Access Compliance Report

Public Rights-of-Way

(Pedestrian Signals)

Intersection ID: N/A	Main Street:	Cross Street: N/A	Location: N/A
ADA ID: A6A8D30913E2	Signal Type: Two Push Buttons-Non APS	Overall Compliance: No	Severity Score: BTN 1:N/A BTN 2: N/A No BTN: N/A
Codes/Mitigation Info/Possible Solution		Field Measurements/Component Compliance

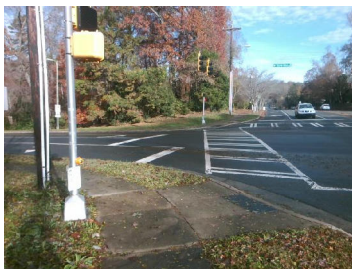
Surveyor Notes: N/A

PROW/ADA: TMUTCD 4e.08, R404.1, R406.2, R404.2, R404.3

Possible Solutions: Replace Signal Push Button With APS Button on New Post. Remove & Relocate Sign.
